# Town of Southampton, NY

## Riverside Revitalization Sewage Treatment Plant and Collection System

### Value Planning Final Report

Date: November 2, 2021 (revised February 7, 2022)  
Our Ref: 30065414  
Subject: Final Value Planning Report

Figure 2 – FEMA Flood Map

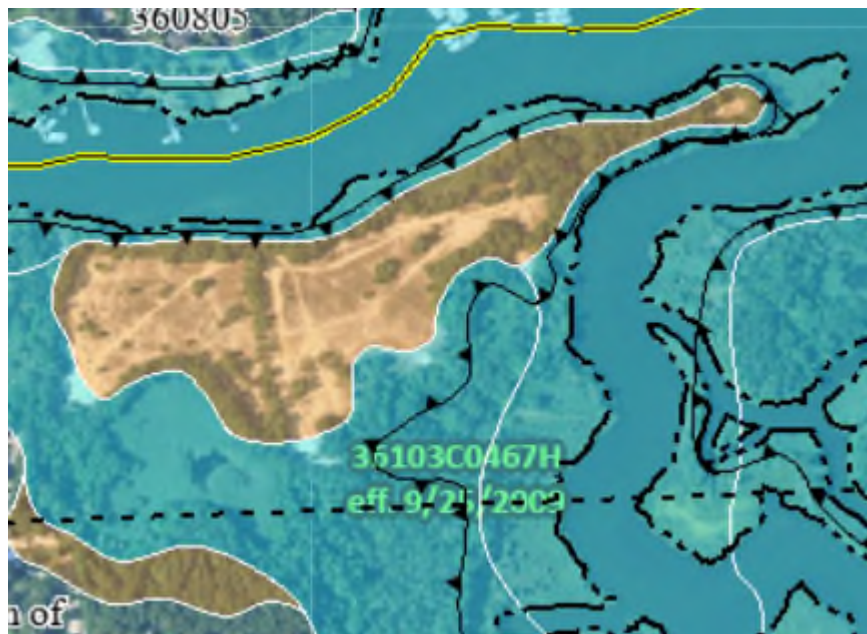
The design documents state that community would be brought on line to the proposed treatment plant in phases, and because of this the flow regime of the constructed wetland would increase over time. As such, the constructed wetland should be designed to dynamically adapt to different flow characteristics. A potential suggestion would be incorporating micro topography within the constructed wetland cell to allow for an initial mosaic of habitats transitioning to one habitat type as water increases within the cell.

**Cost Evaluation (OPEX)** – shows disposal impacts with solids handling at Riverhead (on a volume basis) or to landfill (on a wet ton basis) – both evaluations include transportation costs by a 3<sup>rd</sup> party to bring material from the Riverside STP to the Riverhead WRRF for processing.

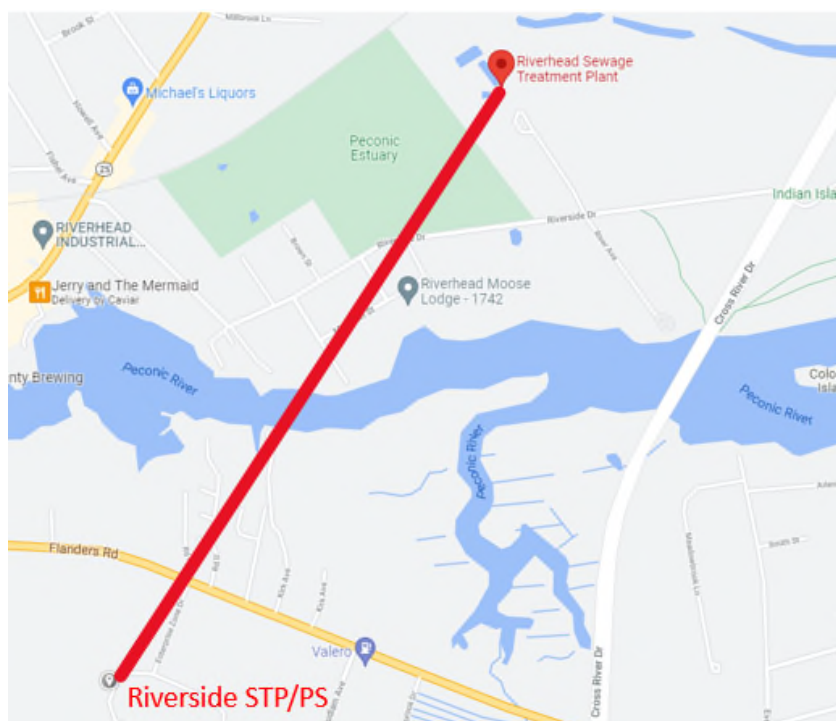
- Discussion:** Incorporation of a gravity belt thickener will significantly reduce the volume of sludge produced and transported as solids percentage is increased from 0.5% to 5.0% leading to nearly a 90% reduction in volume of what is transported to the Riverhead plant. The GBT will increase initial capital costs but will lower sludge disposal costs, lower energy and polymer usage, lower labor cost and transportation costs, and provide for reliable solids operations at the Riverside facility.

REMOVE GENERATOR ROOM FROM NEW TREATMENT PLANT BUILDING AND PLACE OUTSIDE OF THE BUILDING AND REPURPOSE SPACE

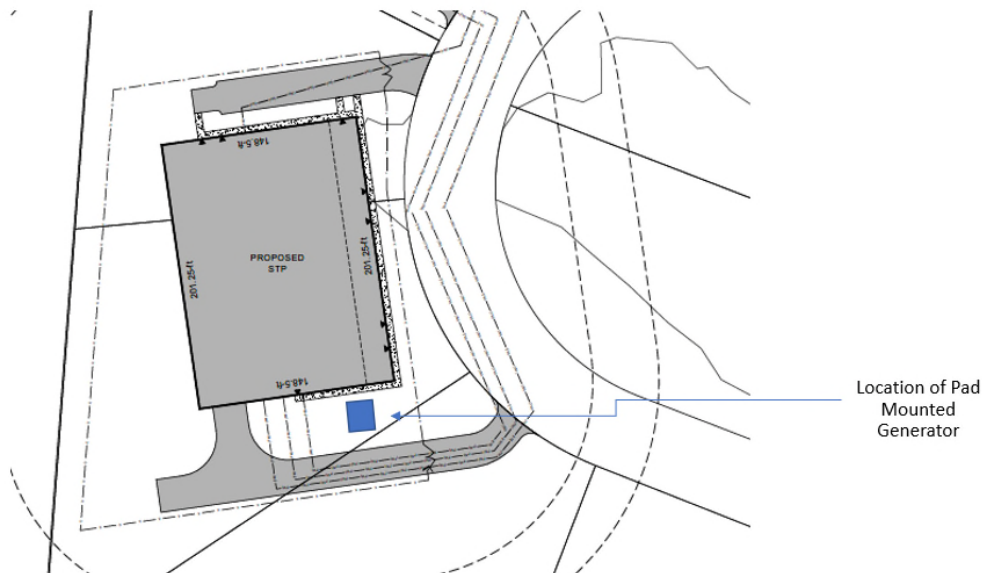
1. **Description of Baseline Concept:** The engineering report indicates that the southern extents of the treatment building incorporates a lavatory, a laboratory, a blower room, an electrical room, and a generator room as shown below:

2. **Description of Alternative Concept:** Proposal targets a modification to the non-process space that relocates the generator outside of the building and utilizes that space in the building to either expand the laboratory room or the electrical room. Proposed location of generator is moved to the south side of the plant which would require swapping the location of the electrical room and the laboratory and lavatory.

**5. Discussion:** Putting the generator outside may reduce the footprint of the treatment building and will minimize potential impacts to plant operations and air quality concerns within the building. Also this frees up space within the plant building footprint for solids handling/GBT, odor control, and chemical storage and feed systems.

**Figure 2 - Alternative Pumping Station Locations (in Orange)**

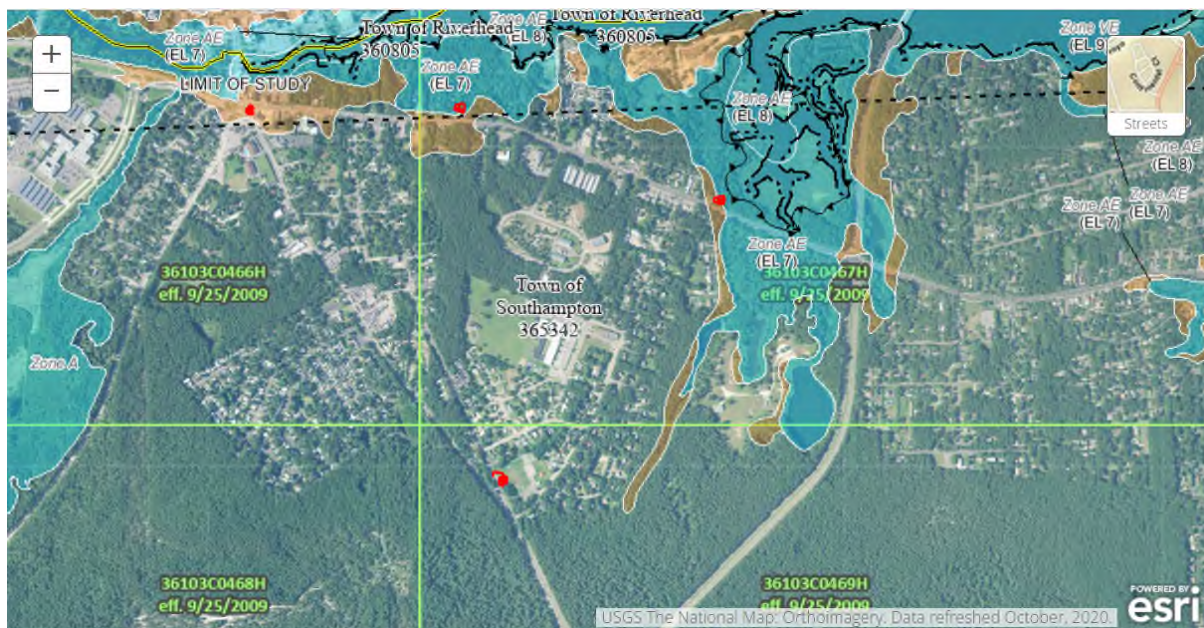
1. **Description of Baseline Concept:** The conceptual design documents show four pumping stations within the proposed collection system. However, as shown the collection system sewers and pumping stations would need to be quite deep, and there are several low-lying areas that would not be able to be served by gravity collection for conveyance. Residences and businesses in these low-lying areas would need to pump their service connection to the sewer district.

The three proposed northern pump stations are within or close to the 100-year flood zone.

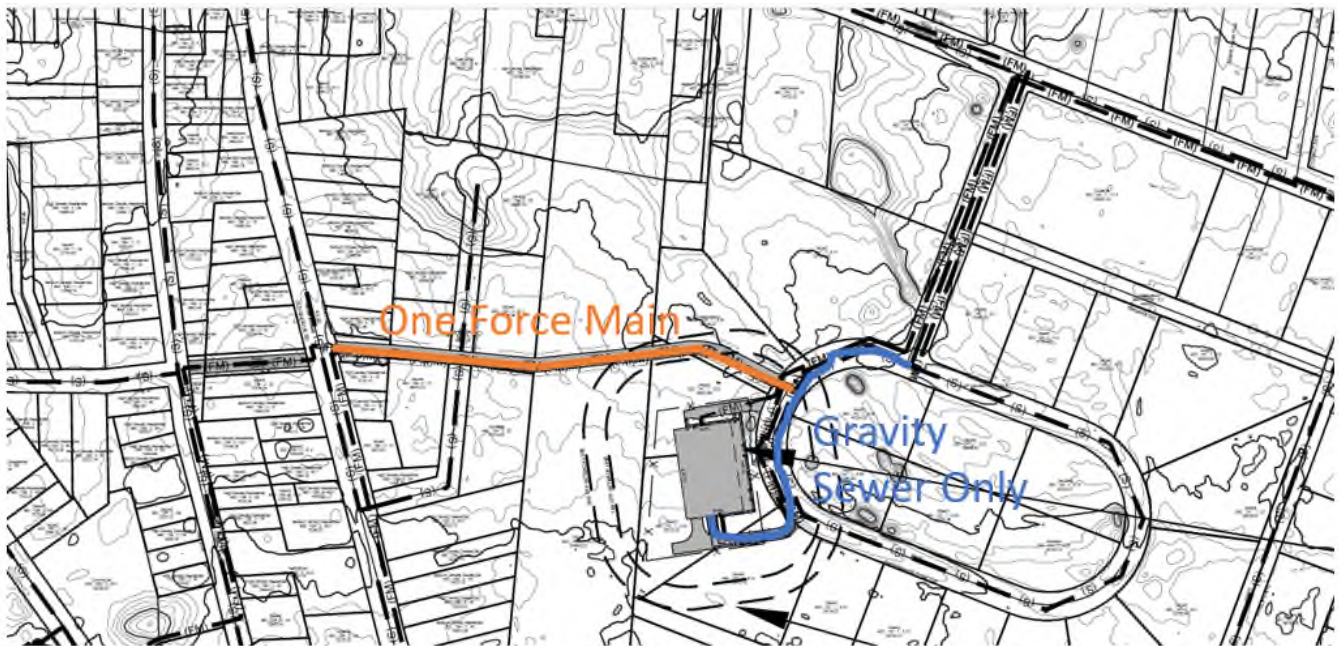
- 1. Description of Baseline Concept:** The conceptual design documents show two force mains running in parallel as they approach the STP from the West, and another force main approaching the STP from the North. All three force mains wrap around the East side of the STP before entering the influent lift station on the south side of the STP
